**CAPILLARY THERMOSTAT HOLDER REVISION**

For all cookers (gas/electric); the capillary thermostat bulb holder has been changed after 24.11.2011 as an improvement modification. (Thermostat holder is well fixed on the cavity so that the stability of the thermostat bulb position is guaranteed even in the condition of vibration/ impact or etc..) and thus the thermostat sensibility will be guaranteed.

**CAPILLARY TUBES PLACED ON THE NEW HOLDERS**

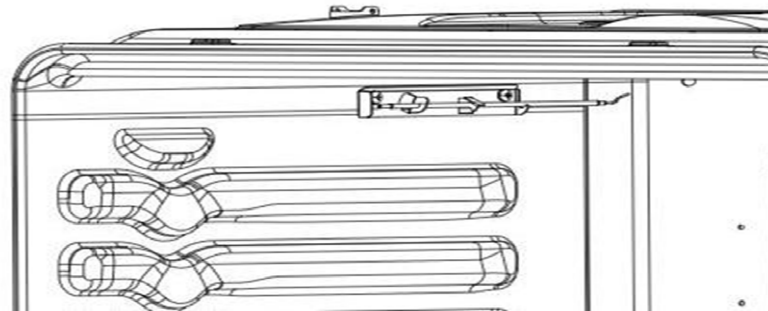
Thermostat holder is well fixed on the cavity so that the stability of the thermostat bulb position is guaranteed (even in the condition of vibration/ impact or etc..) and thus the thermostat sensibility will be guaranteed.

Changing parts are **not interchangeable** because of:

1. Thermostat holders (due to the positioning holes are different from the current version)
  - Please **order old thermostat holder for old productions!**
2. Cavity (due to the new holes for thermostat holder)

If you order old cavity, you will send the **new cavity with the new thermostat holder assembled on it.**
